Office Action Summary	Application No. 10/765,738	Applicant(s) MCDONOUGH ET AL.	
	Examiner Steven Wong	Art Unit 3711

2. The text of those sections of Title 35, U.S. Code not included in this action can be found in a prior Office action.
3. Claims 1, 2, 5-7, 10, 11 and 13-16 are rejected under 35 U.S.C. 102(b) as being anticipated by Chase (3,414,268).

GOLF TEE WITH SEAT FORMED BY COACTING CENTRAL
PART AND RADIATING PETALS

FIG. 5.

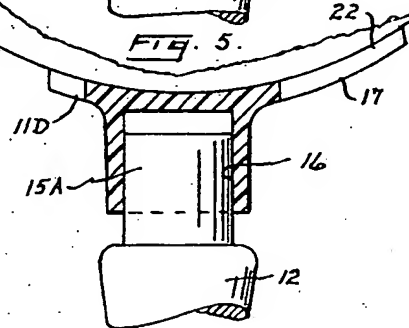
Regarding claim 11, the applicant argues that the golf ball shown in Figure 5 of Chase appears to contact more than just a portion of the legs. However, this is not persuasive as the leg members of Chase define multiple portions such as an end portion, a top portion and an underside portion. The golf ball as shown in Figure 5 only contacts the top portion of the leg members.
